**Presentation on the Jackson Bluff Dam Spillway Project**

**RE: Surface Water Management Application 04-2009-0006 I**  
**Jackson Bluff Dam Spillway Modification – Gadsden County**

Re: City of Tallahassee – Corn Hydroelectric Generating Facility  
Spillway Modification Project – Application 04-2009-0006 I  
Request for Information dated October 19, 2009

RE: City of Tallahassee – Corn Hydro Spillway Modification  
Application 20-0296182-001-DF - Request for Additional Information – Item #3

City of Tallahassee  
C. H. Corn Hydro Facility  
Attachment 2 - Hydrographs for 100-Year Flood Condition

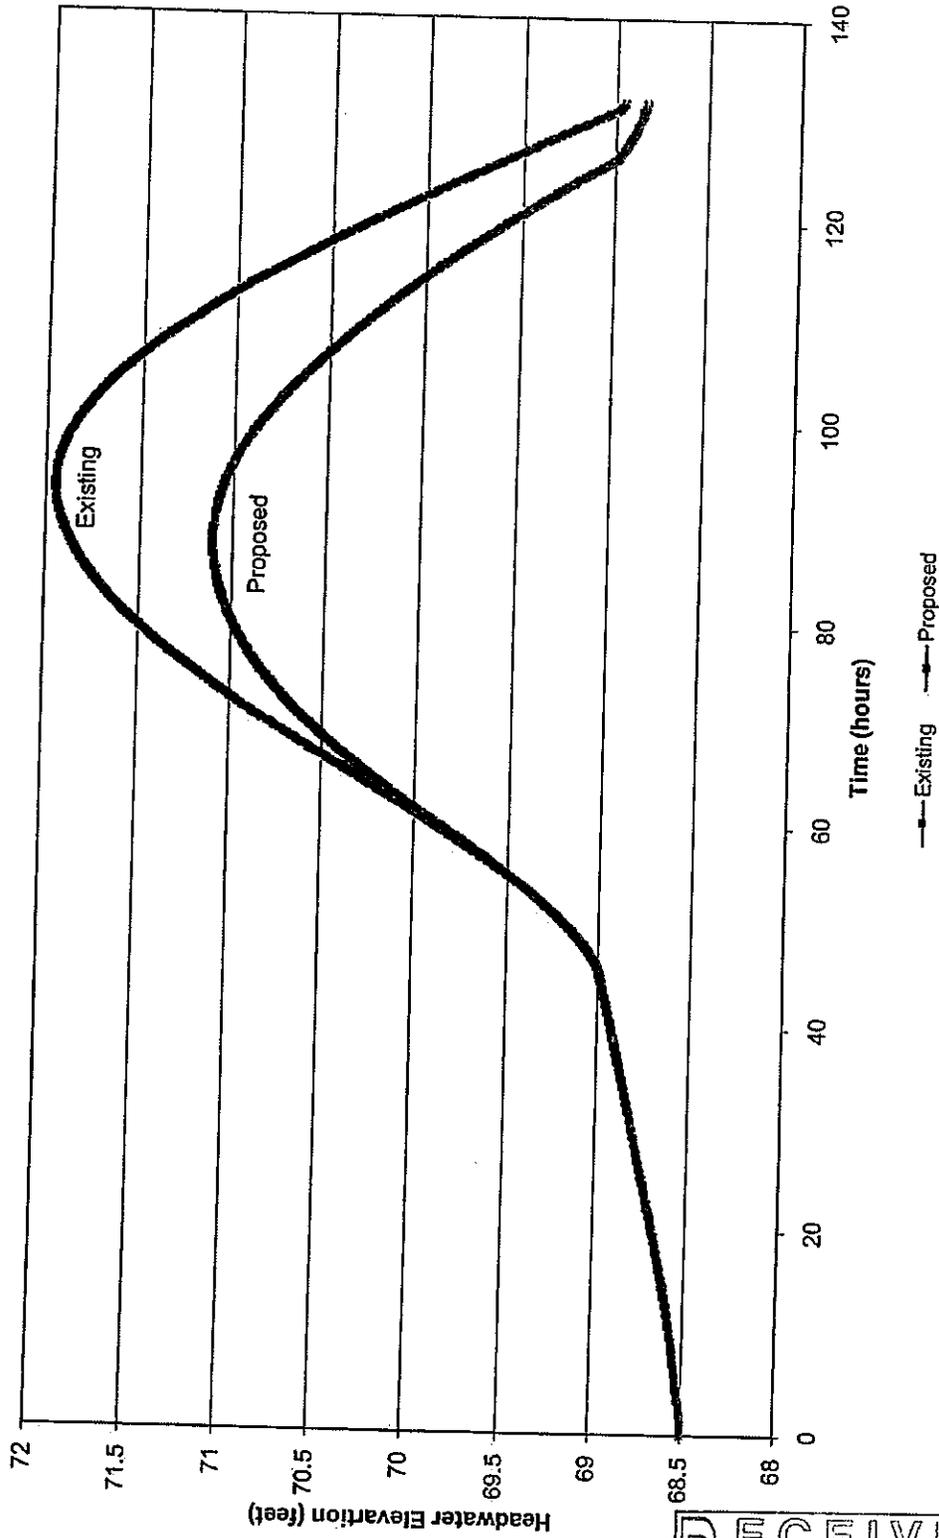
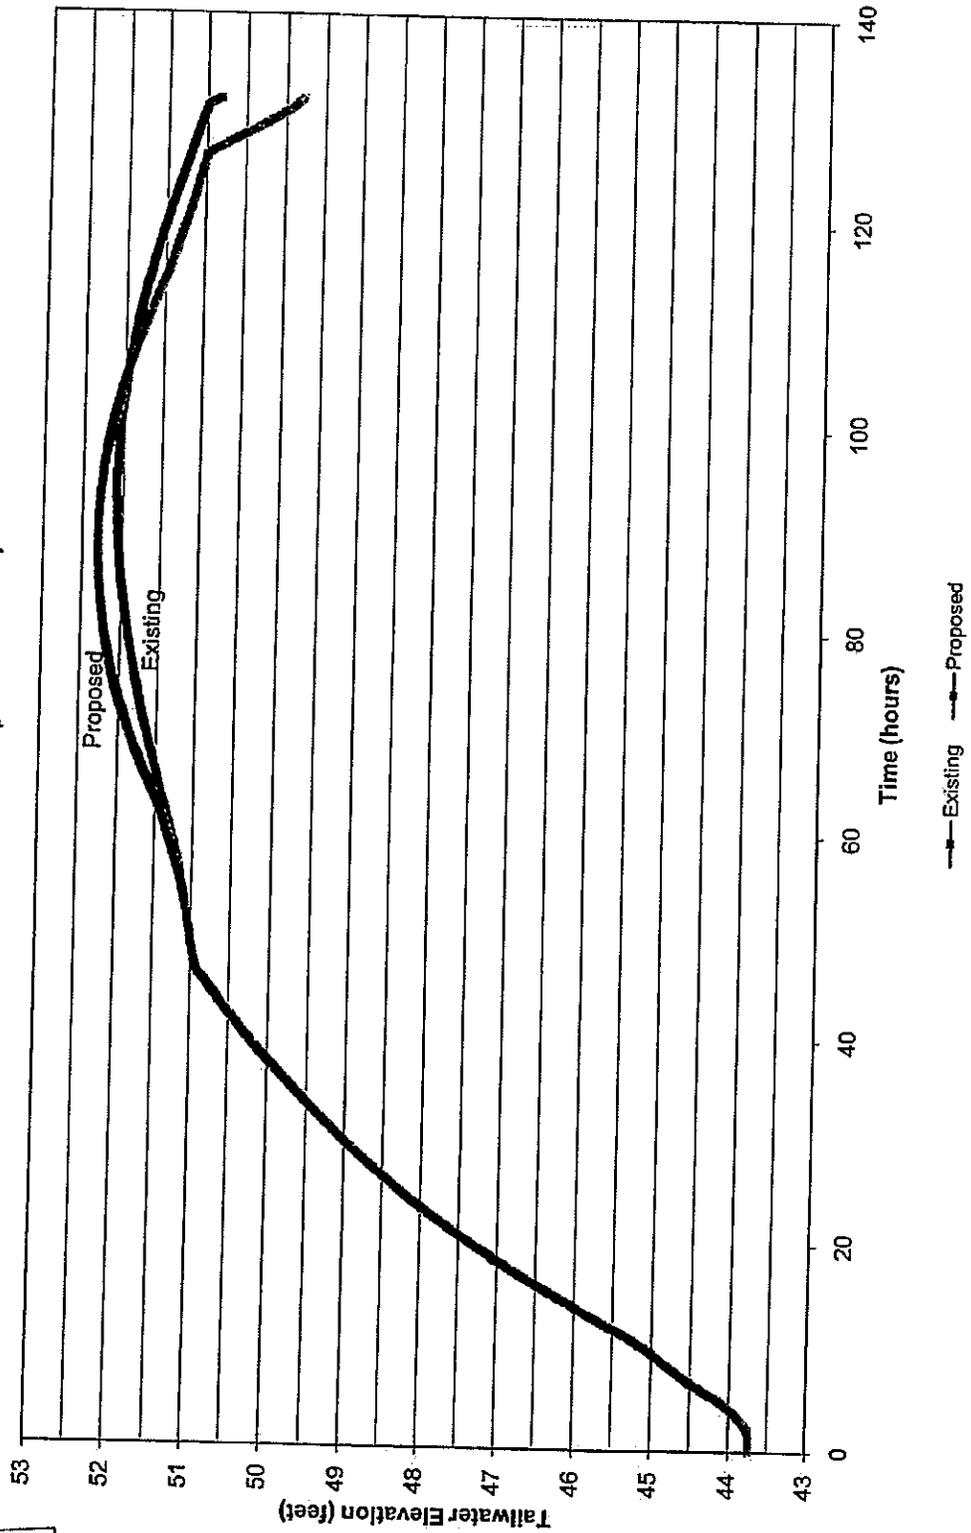
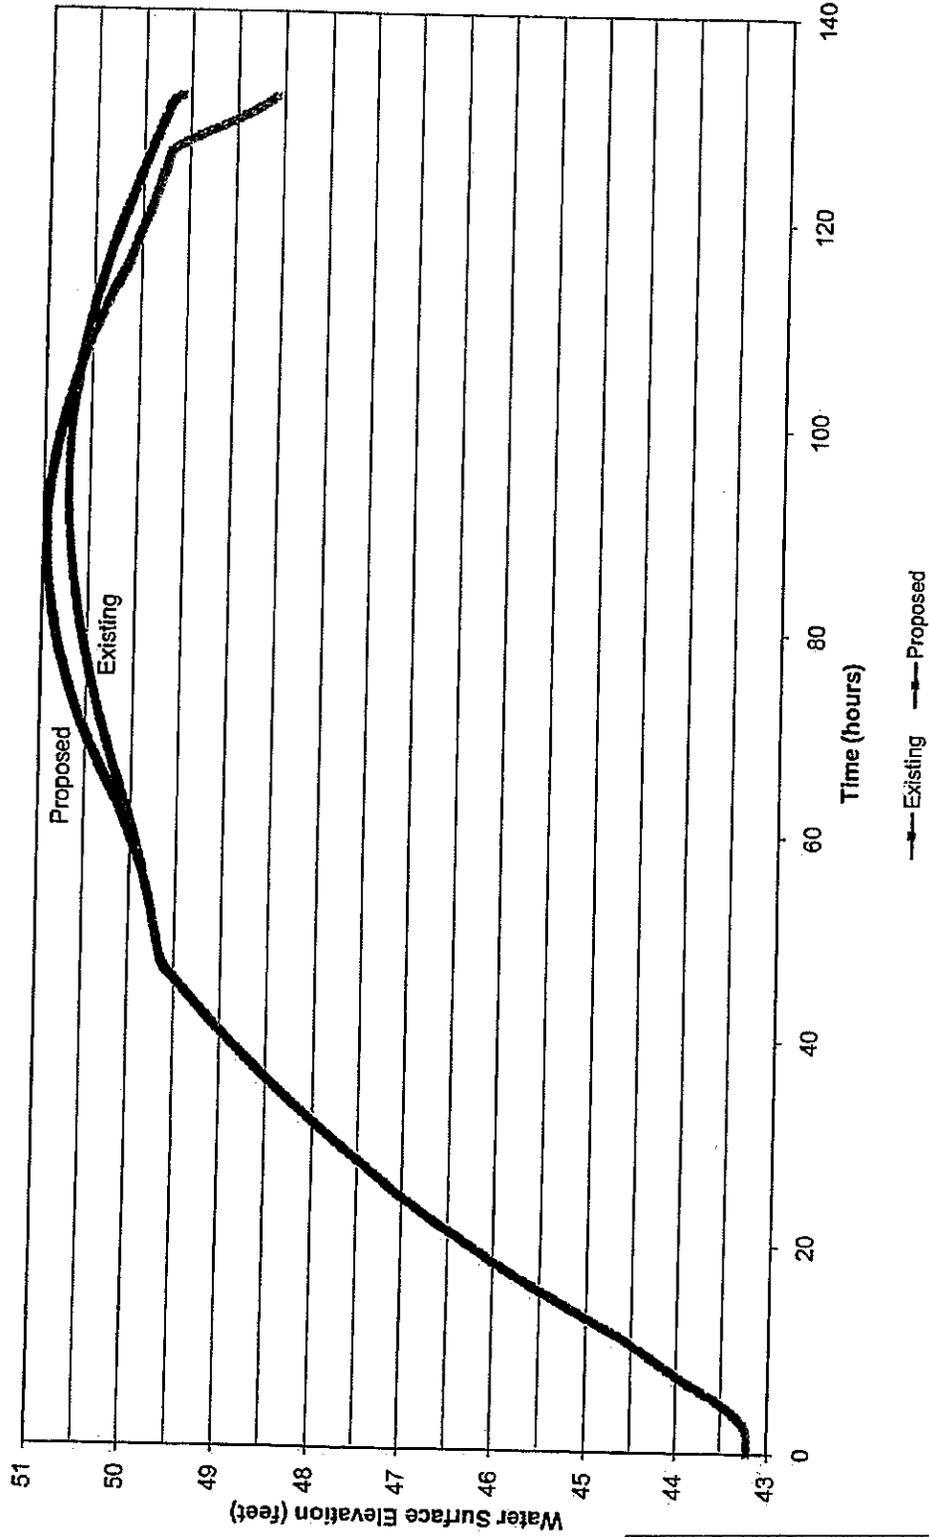
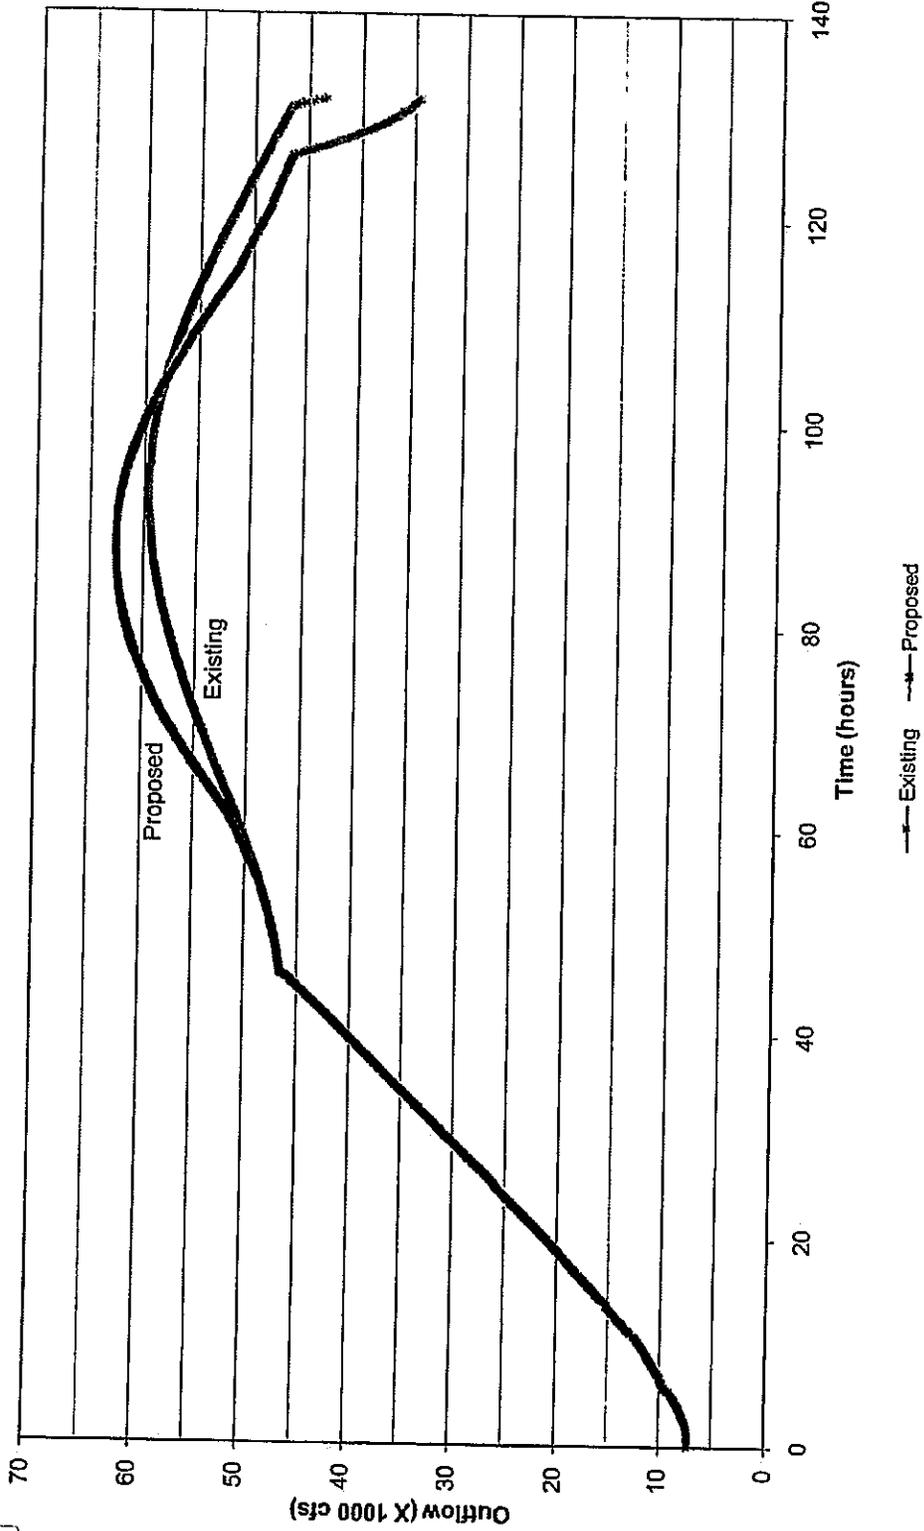
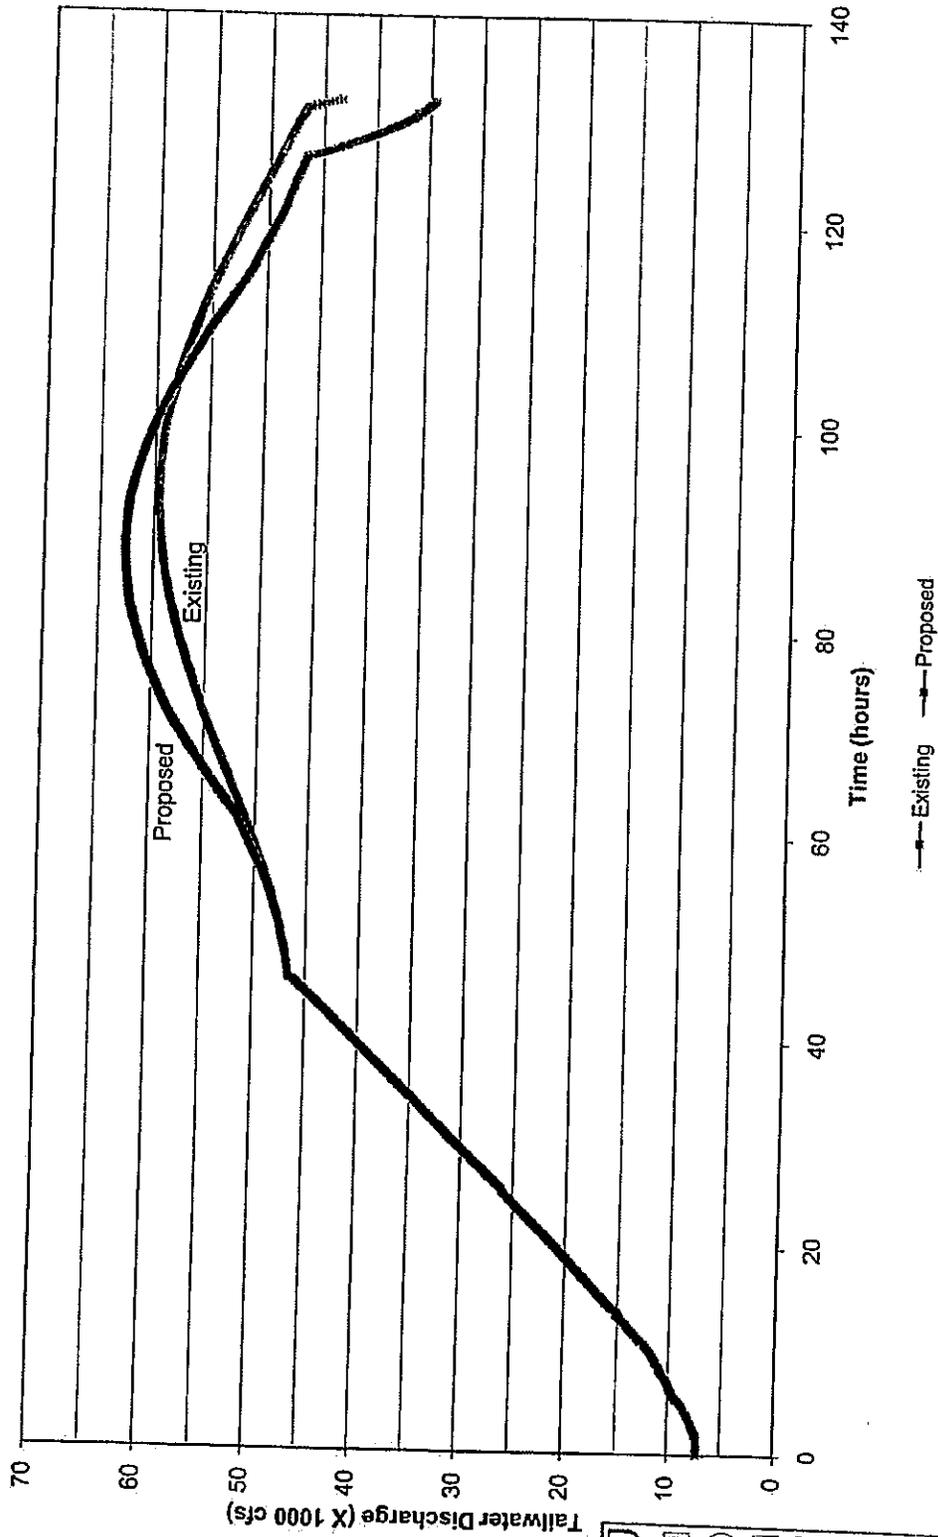
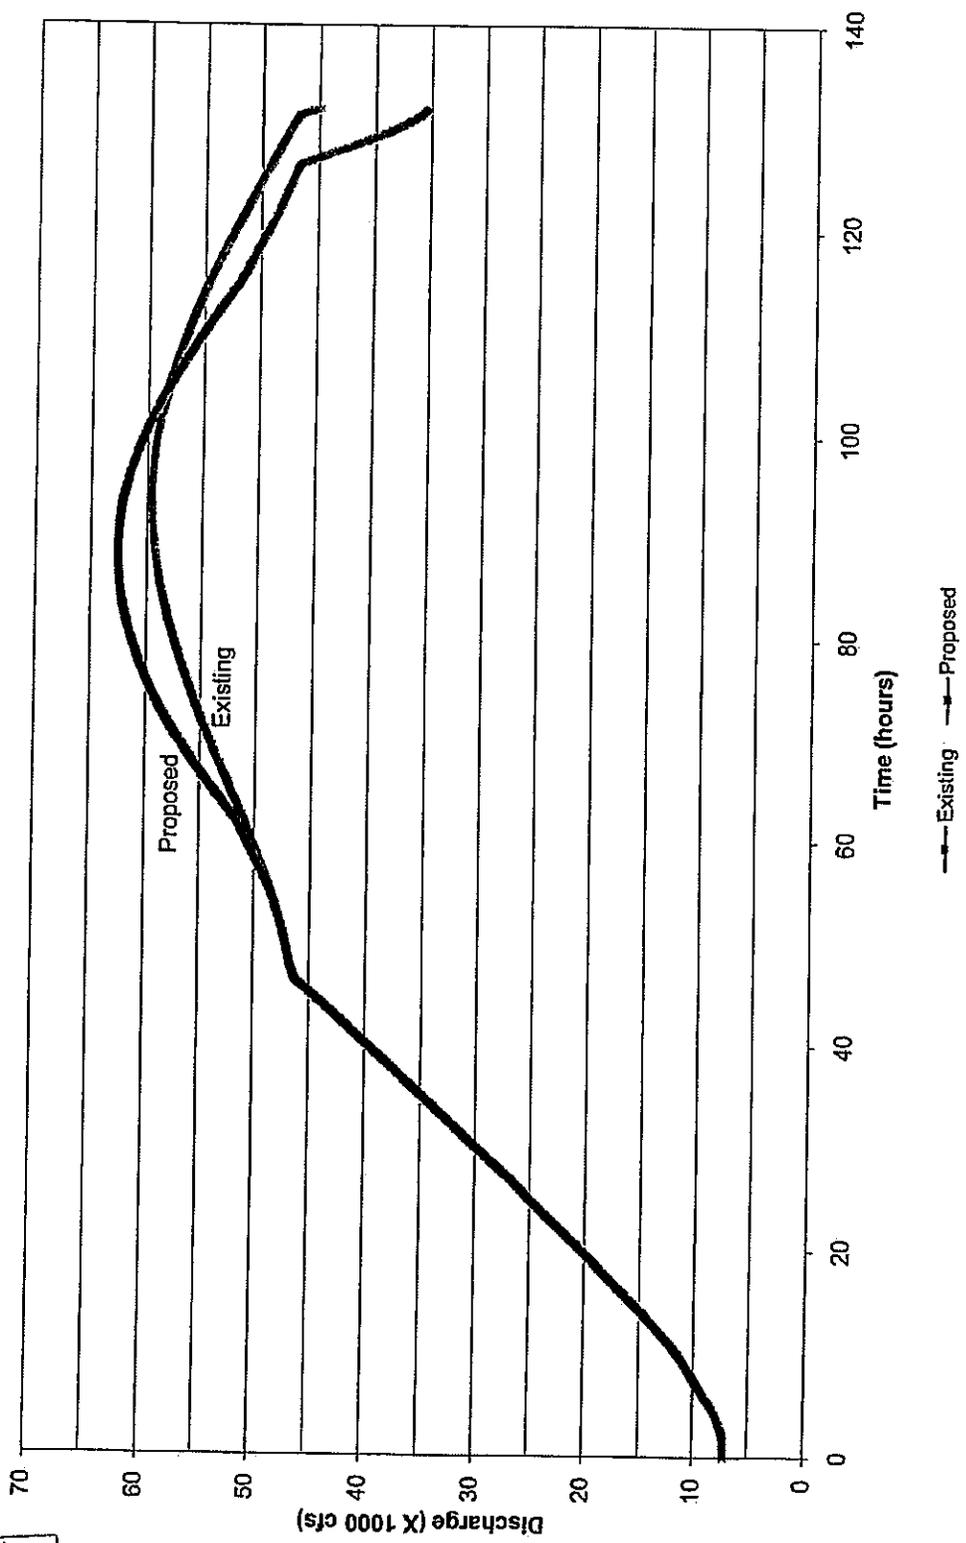
In your letter, you requested the City provide information that quantifies the change in duration, magnitude and frequency of the downstream flooding and the associated impacts from the proposed modification of the Jackson Bluff Dam. Specifically, you requested the City provide pre- and post- impacts to homes, roads, infrastructure, etc. at the 50-year and 100-year flood events. Outlined below is the City's response. This response is based on information developed by Mead & Hunt, the City's engineer for this project.

1. In reviewing Attachment 2, you will note that the average river velocities downstream of the facility remain essentially the same or lower as the result of the proposed modifications. As a result, there will be no change in scour or erosion as a result of the proposed modification.
